Comment 1 for Proposed Amendments to Commercial Harbor Craft Regulation (chc2021) - 15-1.

Comment 2 for Proposed Amendments to Commercial Harbor Craft Regulation (chc2021) - 15-1.

Re: AWO Comments on the
Proposed 15-Day Modifications to
the Proposed Regulation Order

The American Waterways Operators (AWO) retained Jensen Maritime Consultants (Jensen) to provide an independent engineering review of Cal Maritime’s “Evaluation of the Feasibility and Costs of Installing Tier 4 Engines and Retrofit Exhaust Aftertreatment on In-Use Commercial Harbor Craft”, dated 30 September 2019, which was prepared for the California Air Resources Board (CARB) (Reference 1).

Figure 1: Crowley Tug SCR Arrangement

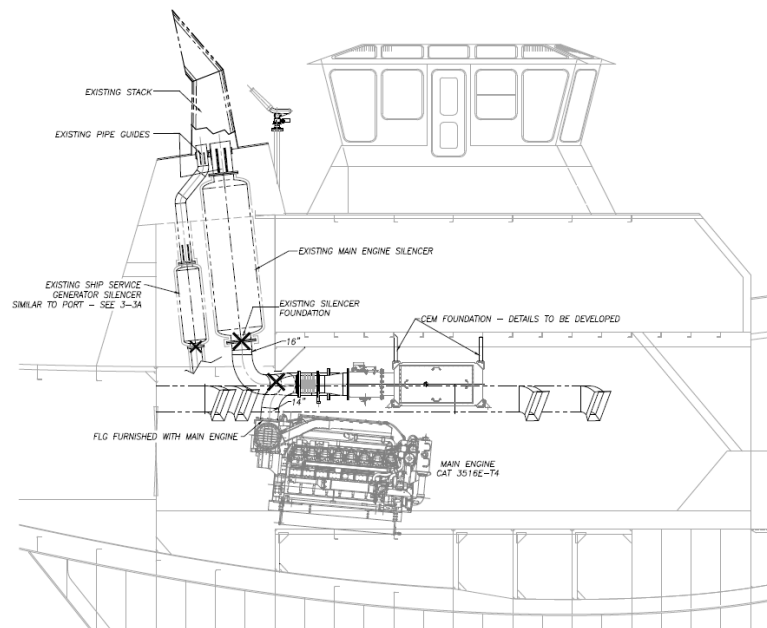
In reviewing the engineering package for the Crowley repower project, the following areas have been identified as requiring modification:

- The tug is fortunate to have the available space in the overhead of the engine room so the SCR's were located above the main engines as shown in Figure 1.

- The new Tier 4 engines have the same footprint and mounting configuration as the existing engines so modifications are not required to the engine foundation.
- The following equipment foundations are required:
 - Two (2) new DEF dosing units.
 - Two (2) new main engine exhaust aftertreatment CAT clean emissions modules (CEMs). Note that these are the SCR's.
 - One (1) new harbor generator silencer.
- Subdividing two existing ballast tanks to partially convert to DEF storage.
- Compartment and tank testing for DEF tanks

Figure 2: Example of SCR Located in the Stack

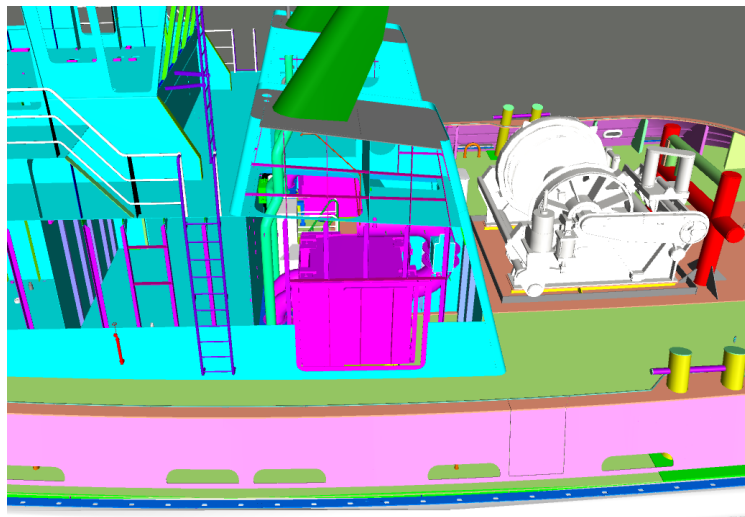
As described above, the engine room of a ship assist and escort tug may not allow for the installation of SCRs in the overhead. In these cases, the SCRs may need to be located in the stacks which requires more extensive structural modifications and typically has an impact on the engine room ventilation fan arrangement. This can also create challenges in accessing the SCR for routine maintenance. Figure 2 shows an example of an SCR located in the stack. Note that this was excerpted from a new design.

Figure 1. CARB commercial harbor craft emissions inventory comparison. (CARB 2021)

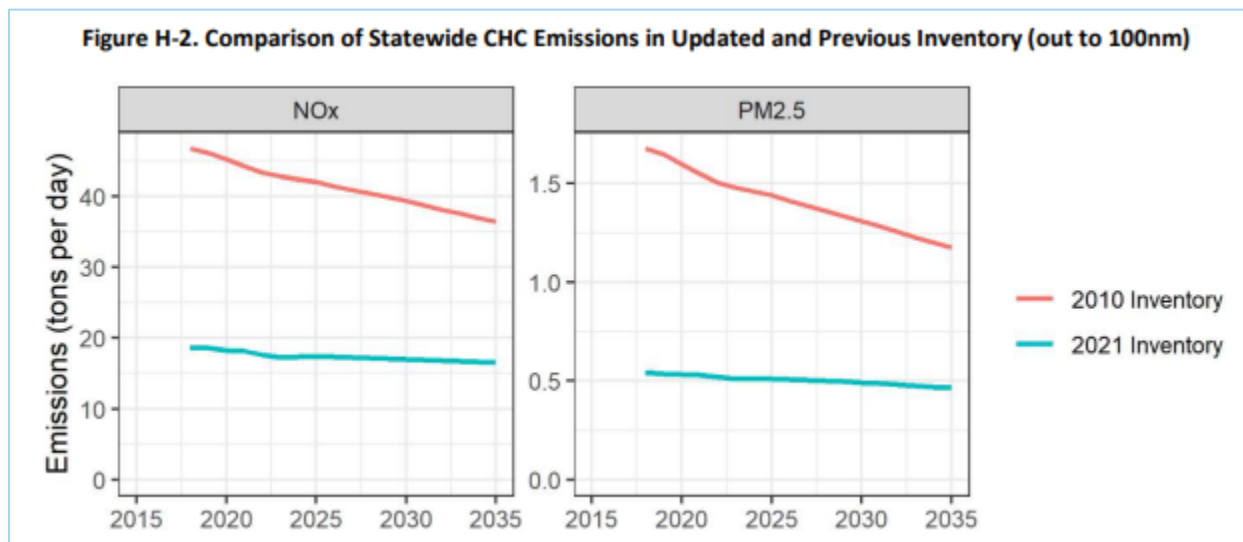
The California Air Resources Board (CARB) air emissions inventory and proposed rule effectiveness are presented in Appendix H of the proposed regulation supporting documentation. This 2021 document updates CARB’s emission inventory methods from the 2007/2009 Commercial Harbor Craft (CHC) emission inventory methods.¹ In general, the approach is similar, but many of the default inputs were substantially revised to lower overall emissions as shown in Figure 1.

Figure 2. CARB commercial harbor craft emissions inventory by vessel type. (CARB 2021)

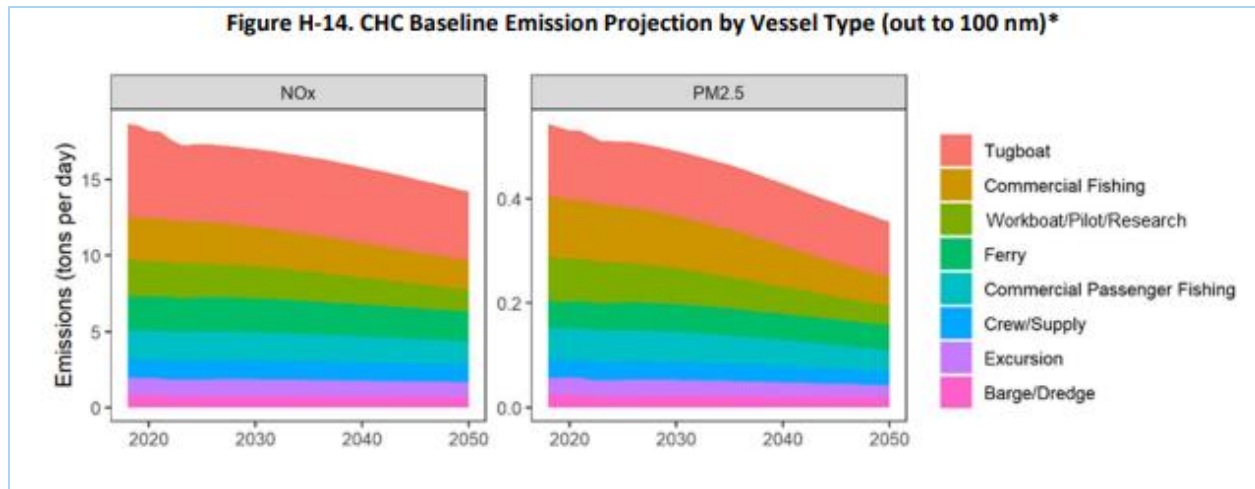
CARB segregated the vessels by type (including vocation) shown in Figure 2. In this report, we focus on the Tugboat types, which include Tugboat-Escort/Ship Assist, Tugboat-Push/Tow, and Tugboat-Articulated Tug and Barge (ATB).
